Camden Town Hall Annexe

Planning Amendments

Crosstree Real Estate Partners LLP

September 2015

Kings Cross

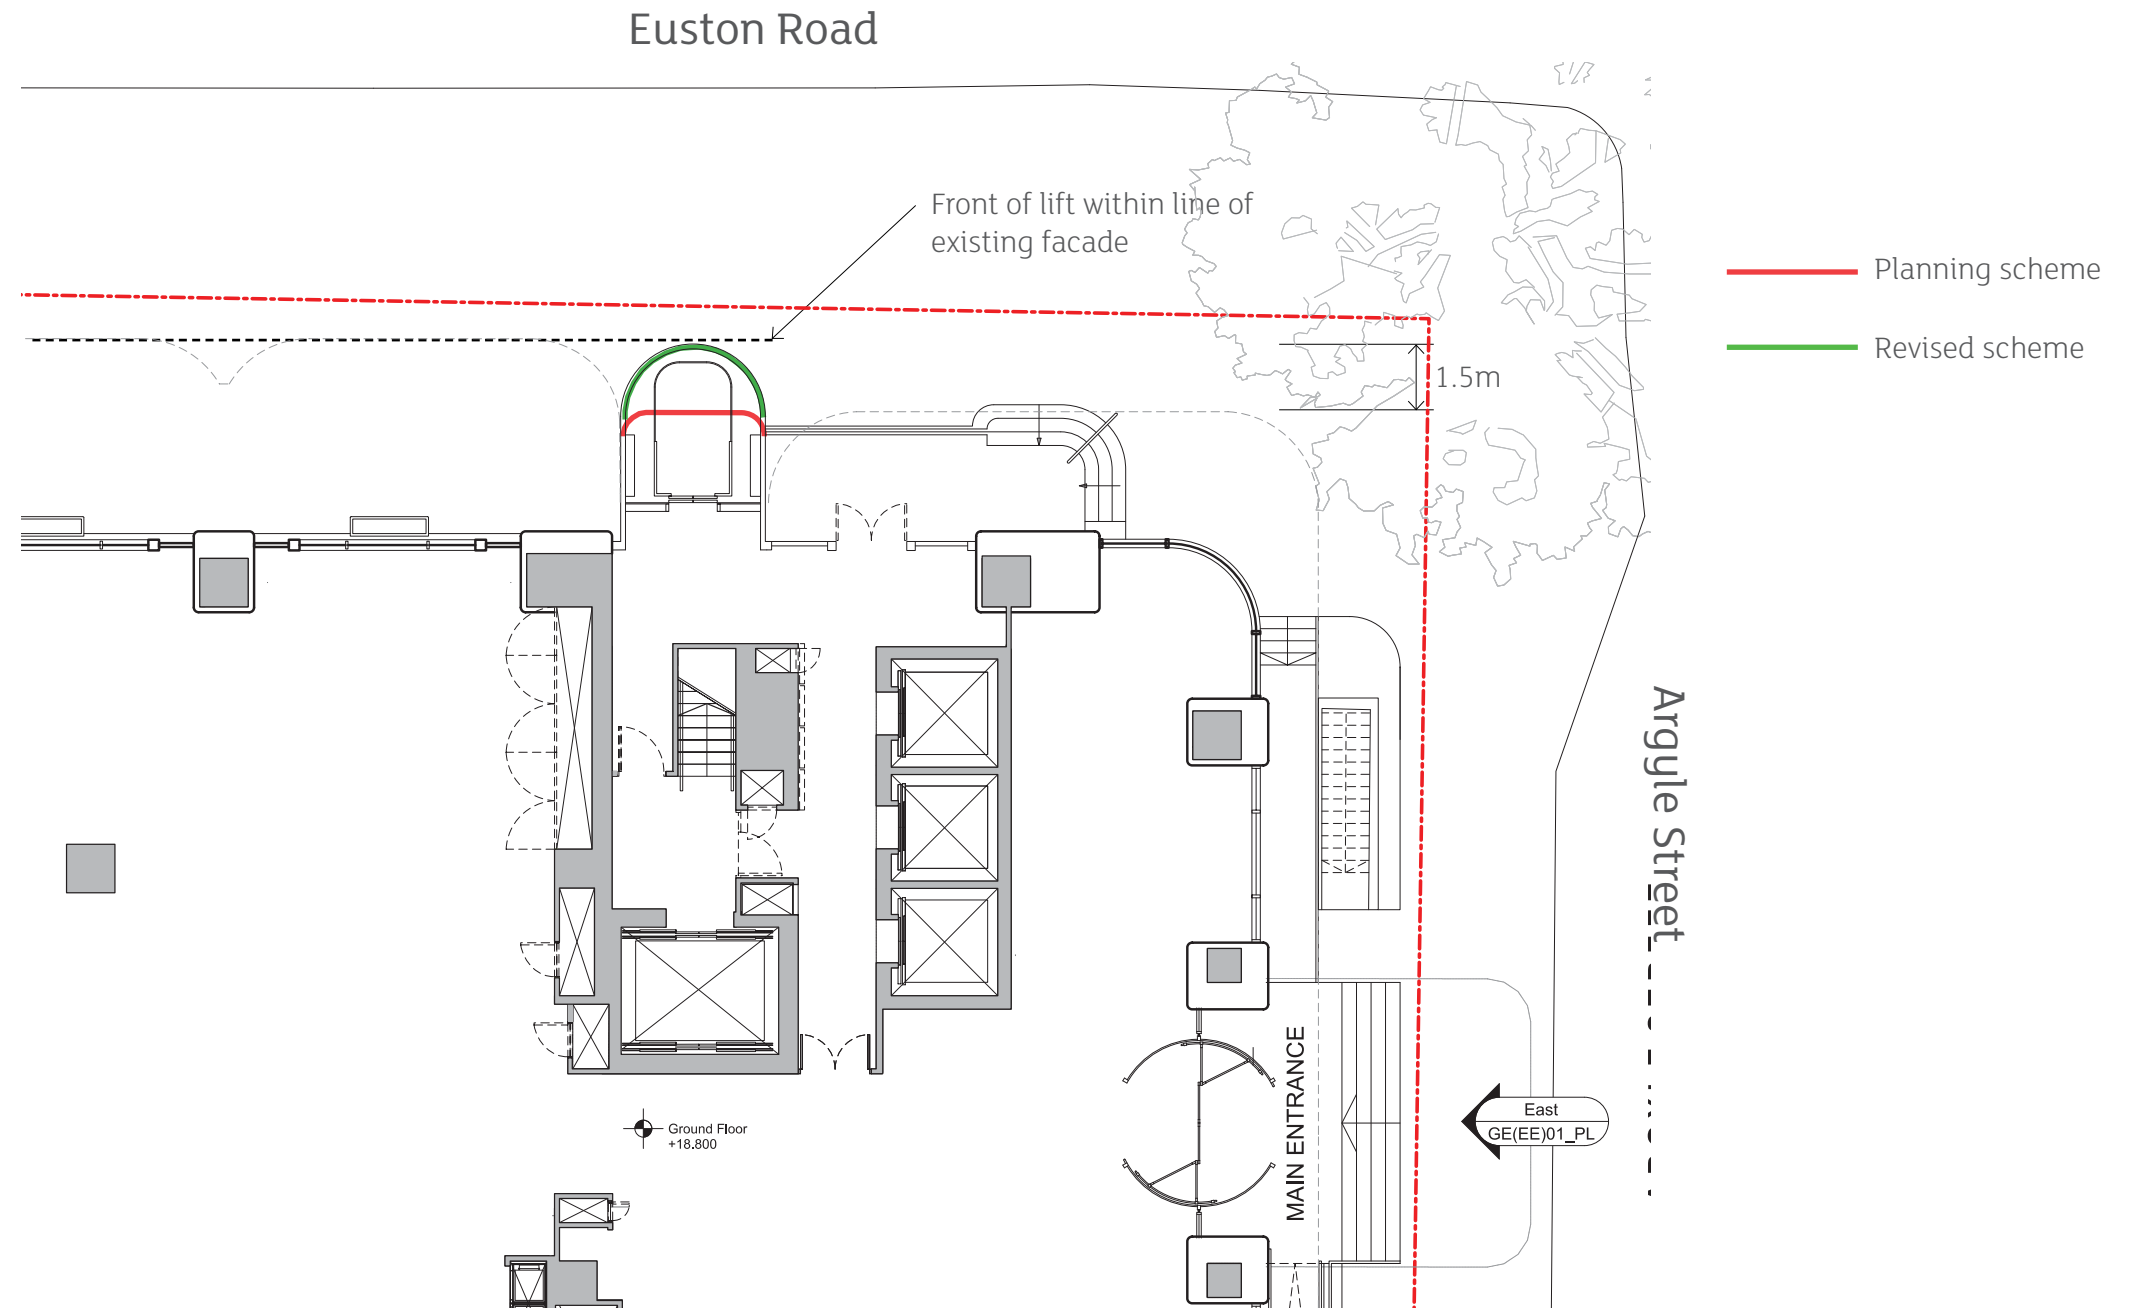
- 1 Deeper fins
- 2 Shallower overhang
- 3 Fins and frame align
- 4 Lift pushed further out
- 5 Metal colour to be confirmed
- 6 Roof light omitted

Planning scheme - Location of goods lift on roof

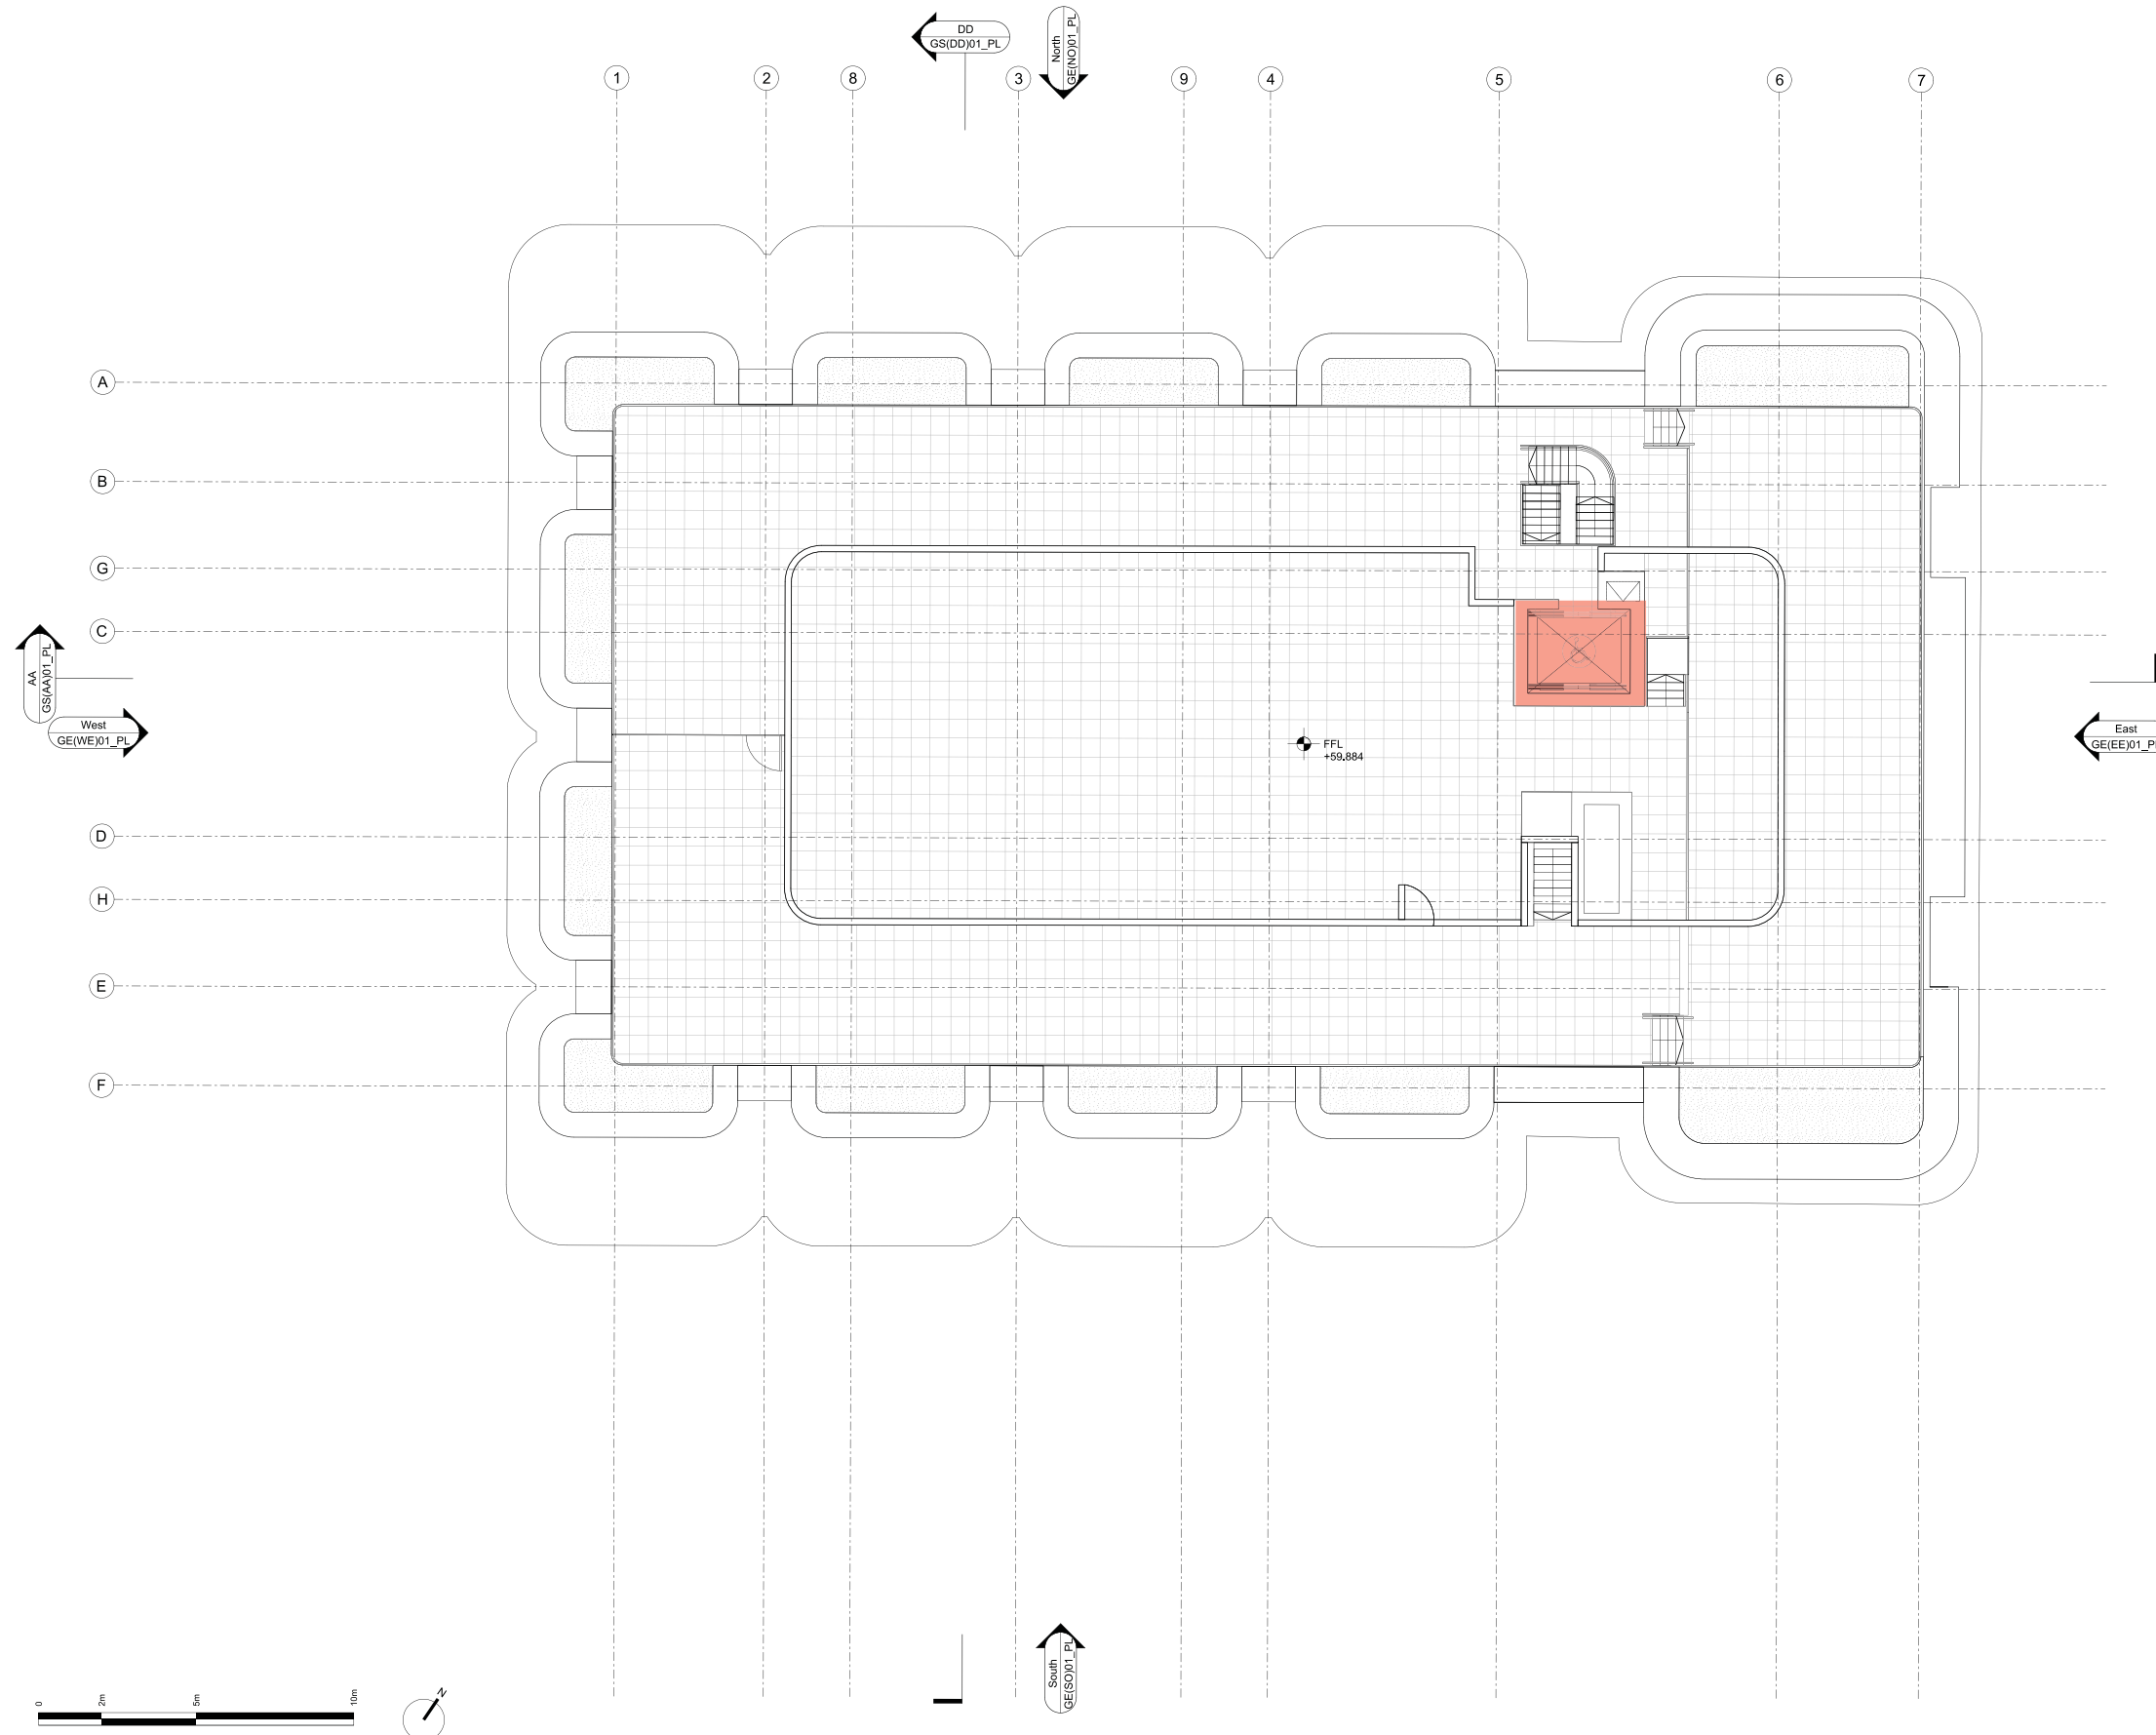
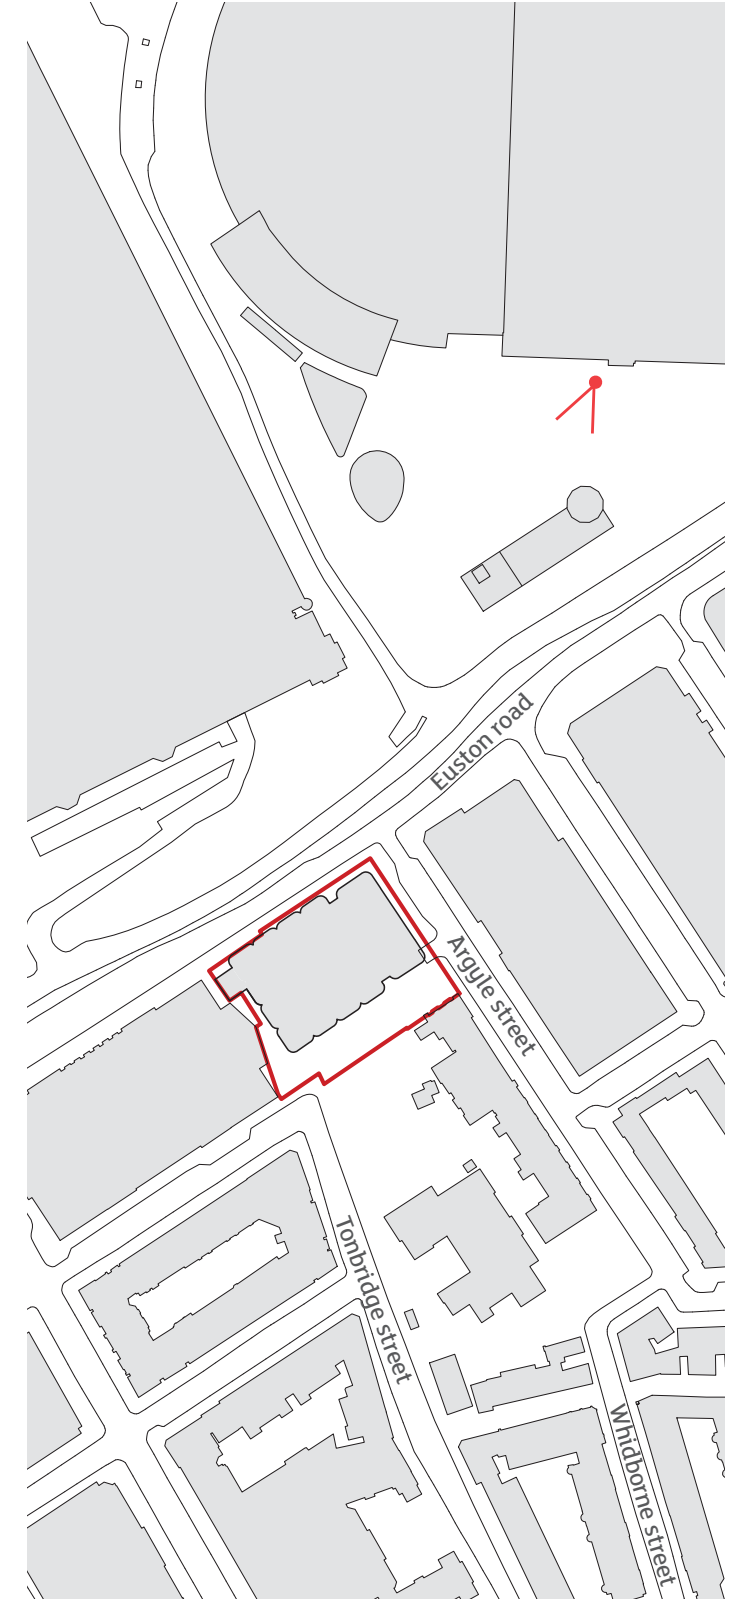
Revised scheme - Location of goods lift on roof
